Panel Report

South Gippsland Planning Scheme Amendment C81 Land Subject to Inundation Overlay

30 March 2016

Appendix D Changes to LSIO mapping

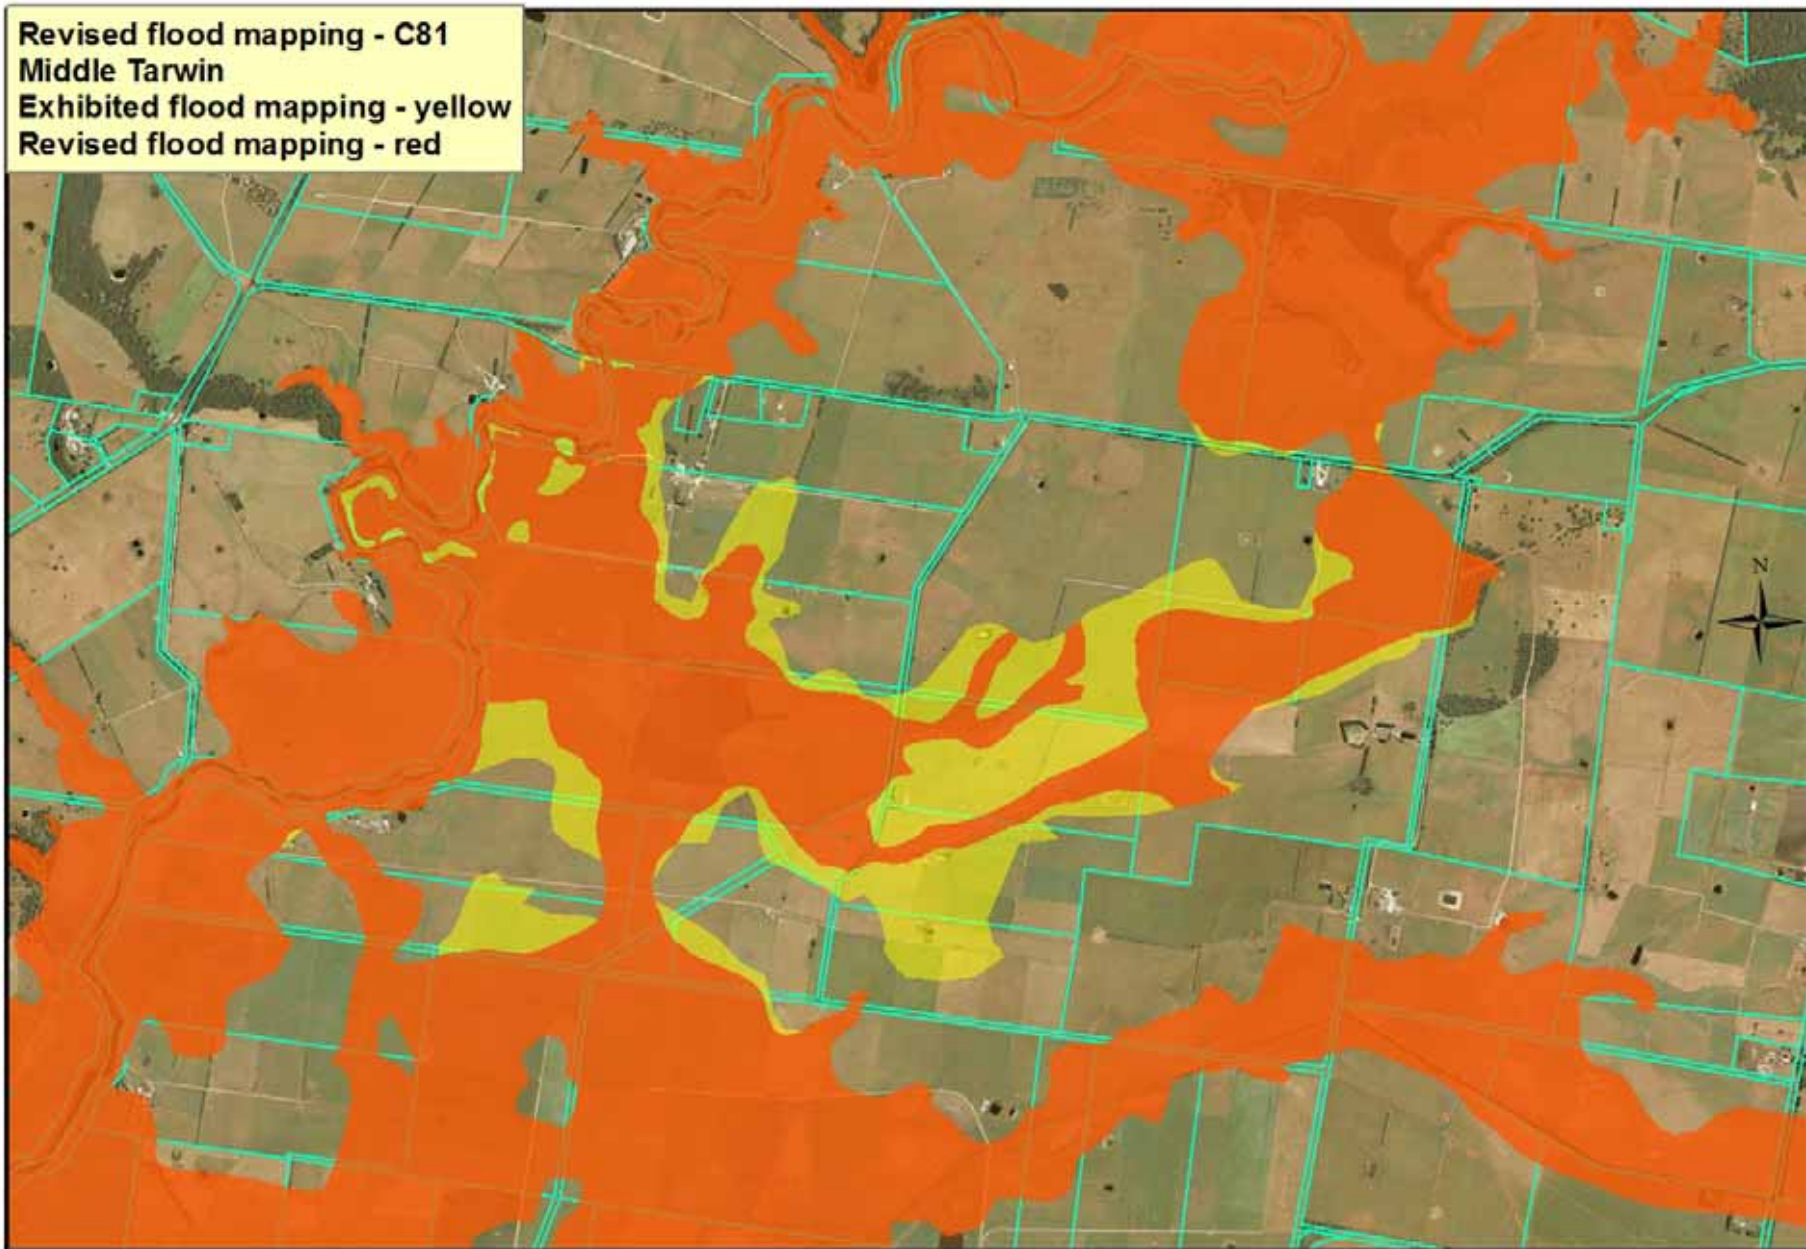
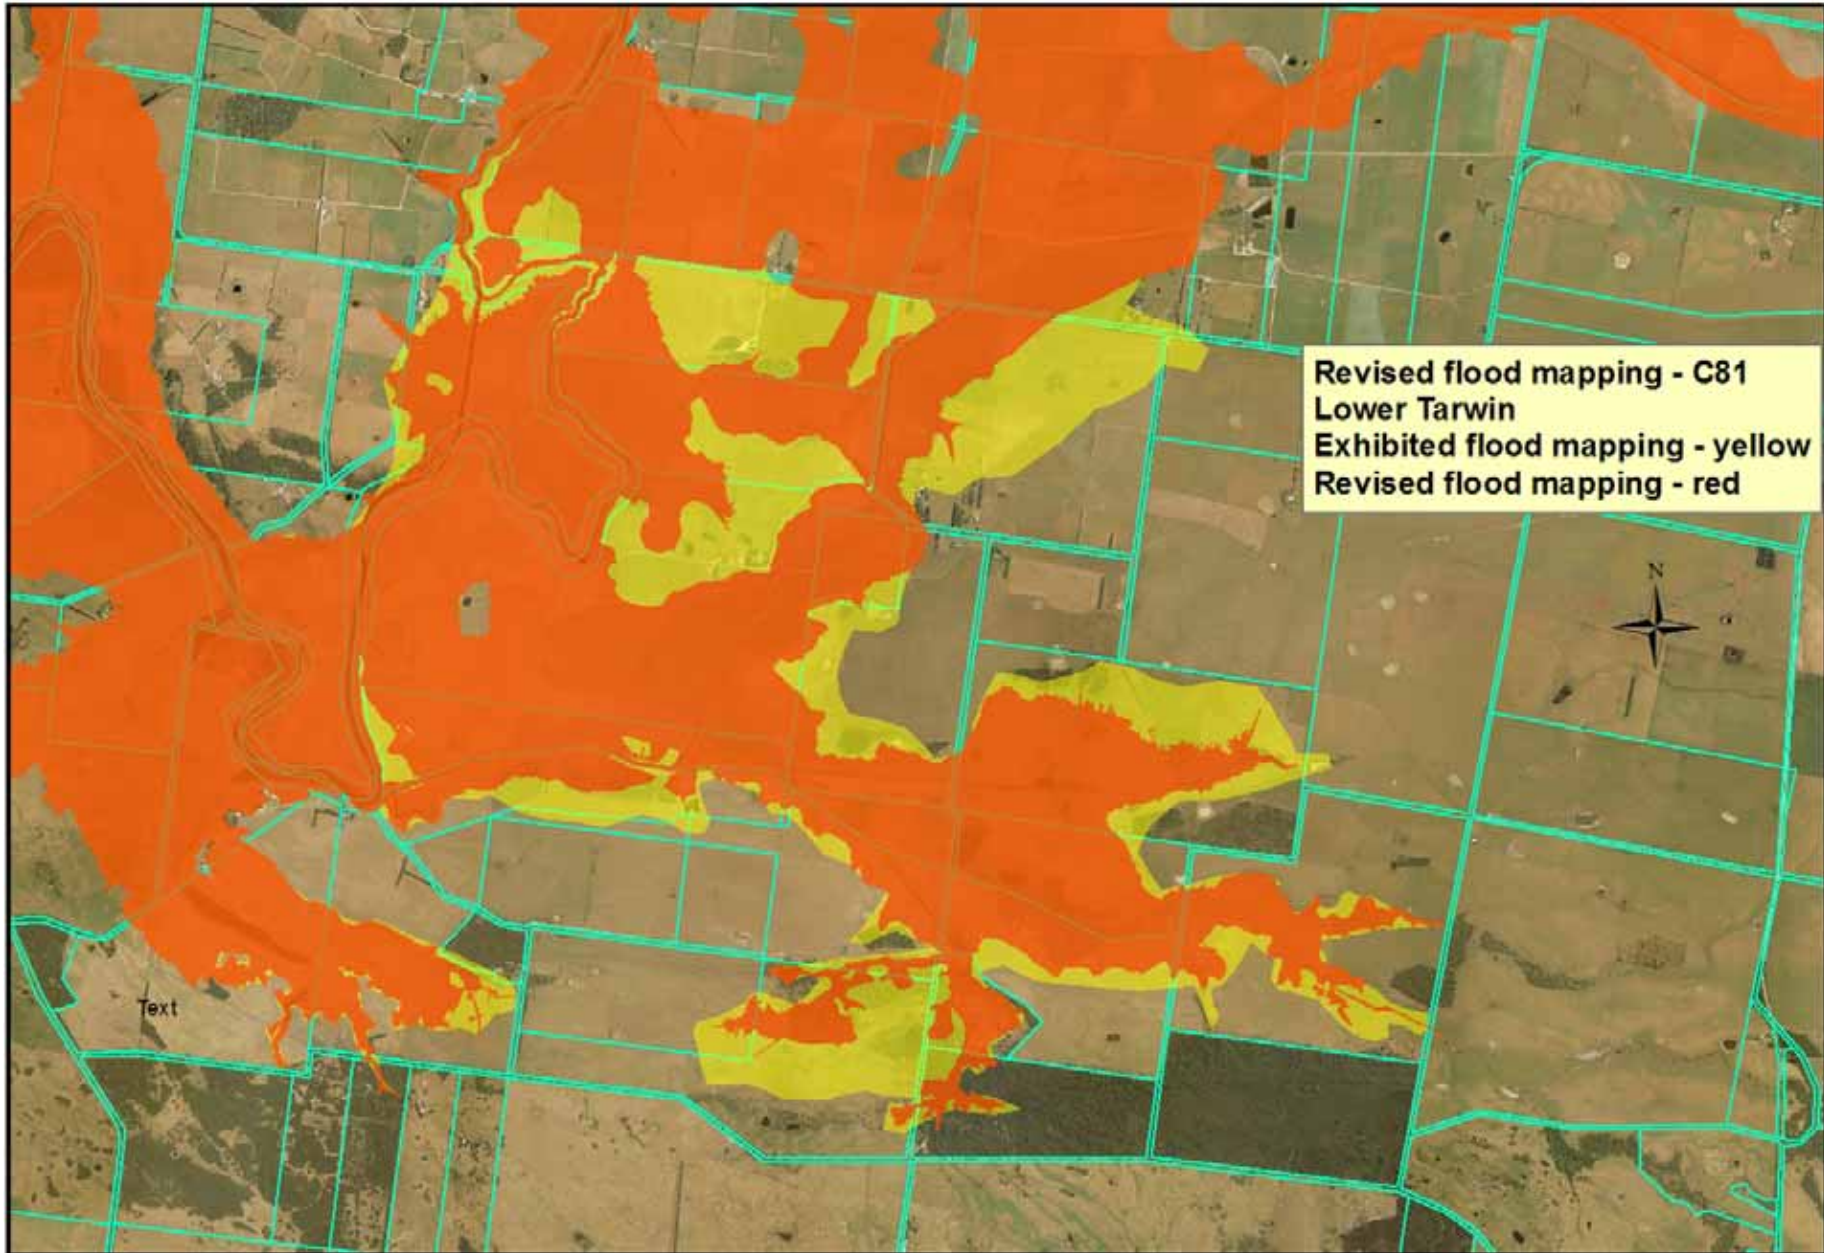
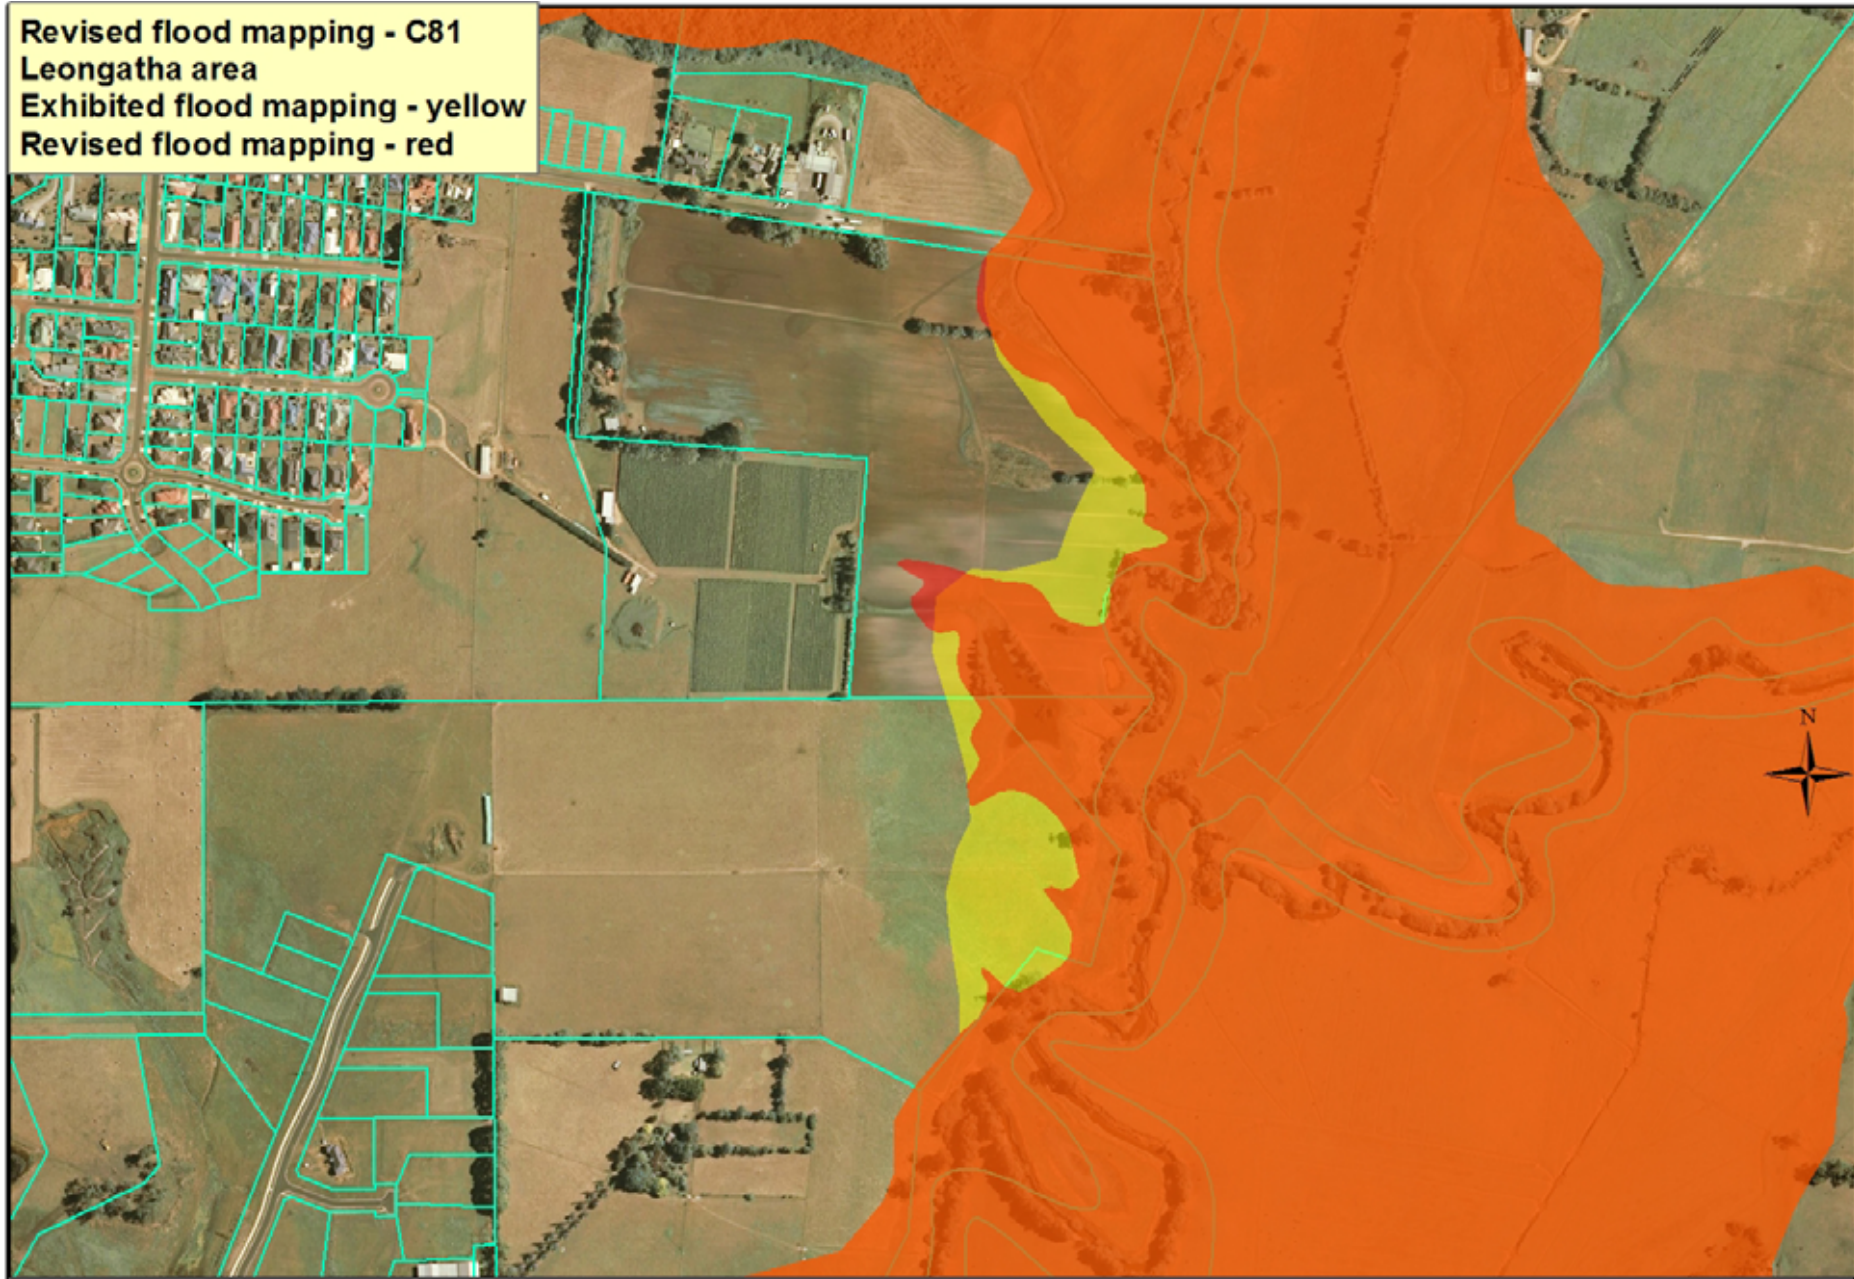
The WGCMA advised that they were contacted by a number of landowners in the Lower and Middle Tarwin River catchments to discuss the extent of the proposed LSIO in those areas. Following on-site visits with landowners and further investigation using LiDAR, WGCMA have proposed revised LSIO mapping in those areas. It is understood that the revised mapping is agreed by the landowners.

The WGCMA advised that they were contacted by Mr Murrhly to discuss the extent of the proposed LSIO on his property east of Leongatha. Following on-site visits and further investigation using LiDAR and aerial photography, WGCMA have proposed revised LSIO mapping in those areas. It is understood that the revised mapping is agreed by Mr Murrhly.

- 3. Amend the revised extent of the Land Subject to Inundation Overlay in the Lower Tarwin, Middle Tarwin, Leongatha and Upper Powlett areas consistent with the maps shown in Appendix D of this report.**

Upper Powlett proposed LSIO mapping changes

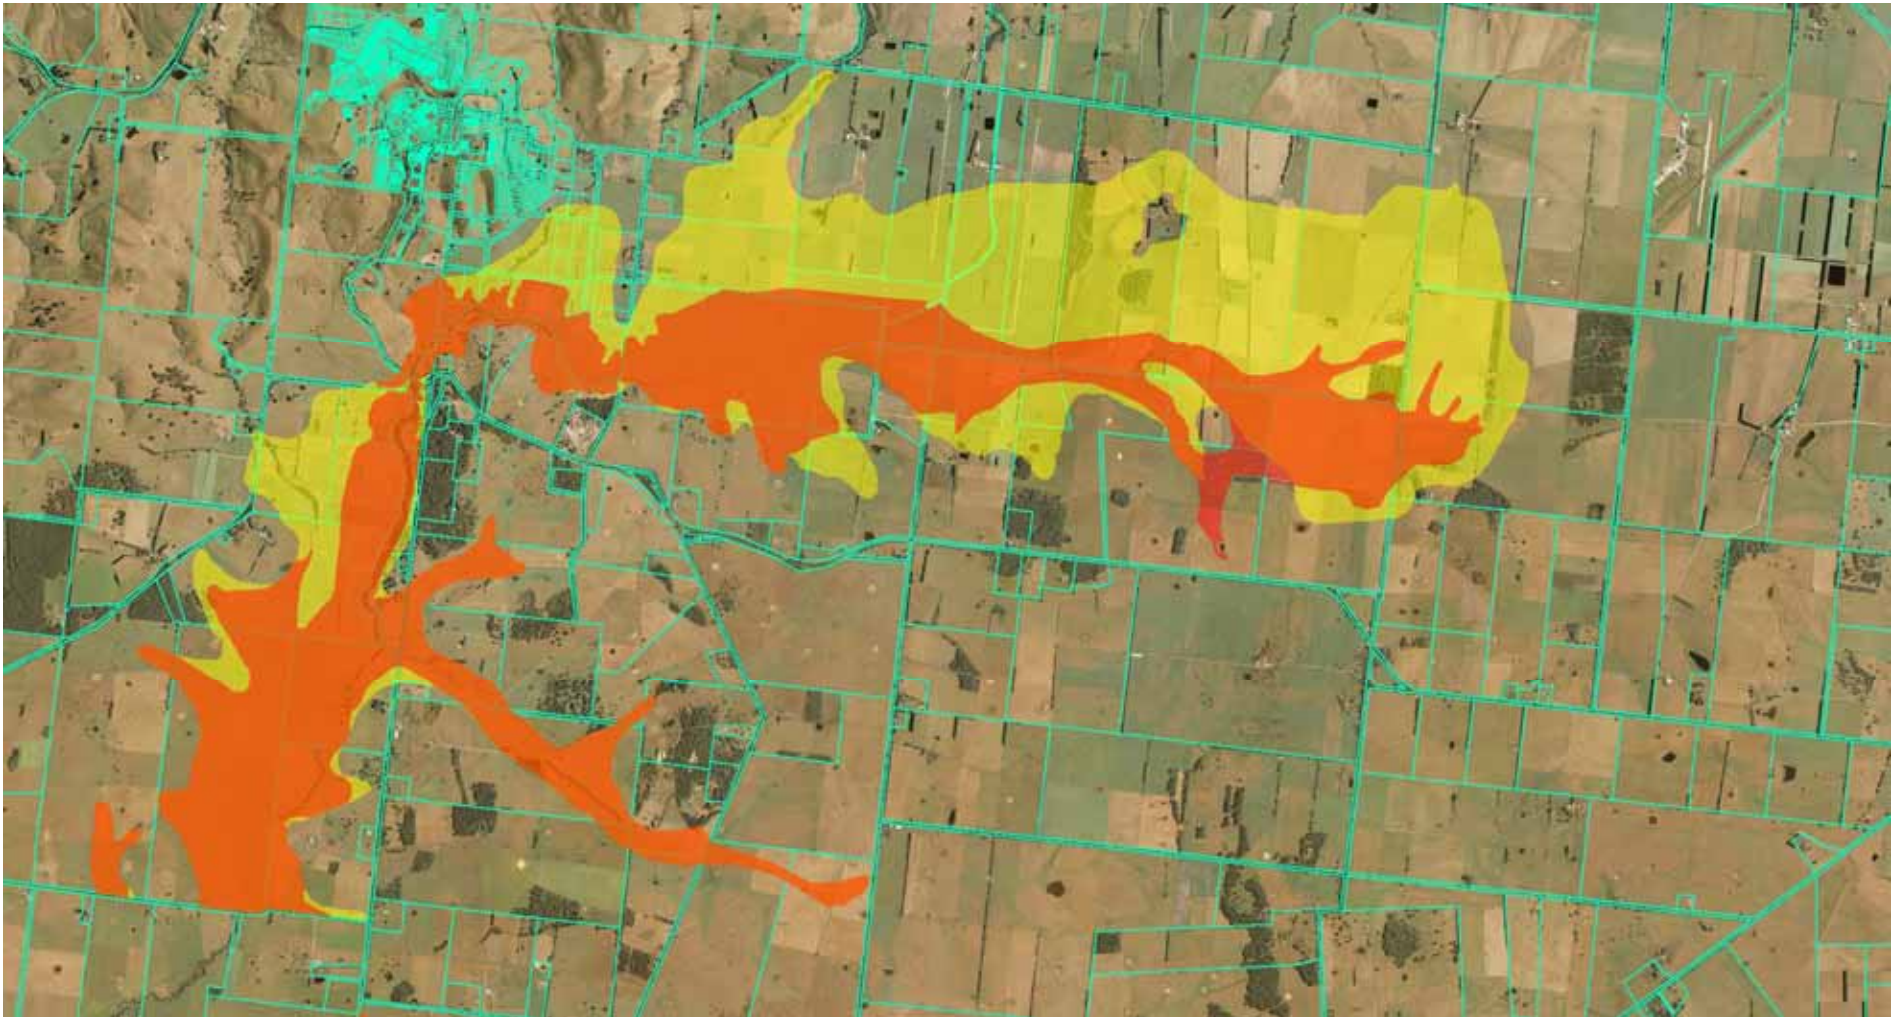
Exhibited flood mapping – Yellow; Proposed flood mapping – Red.

- 3. Amend the revised extent of the Land Subject to Inundation Overlay in the Lower Tarwin, Middle Tarwin, Leongatha and Upper Powlett areas consistent with the maps shown in Appendix D of this report.**
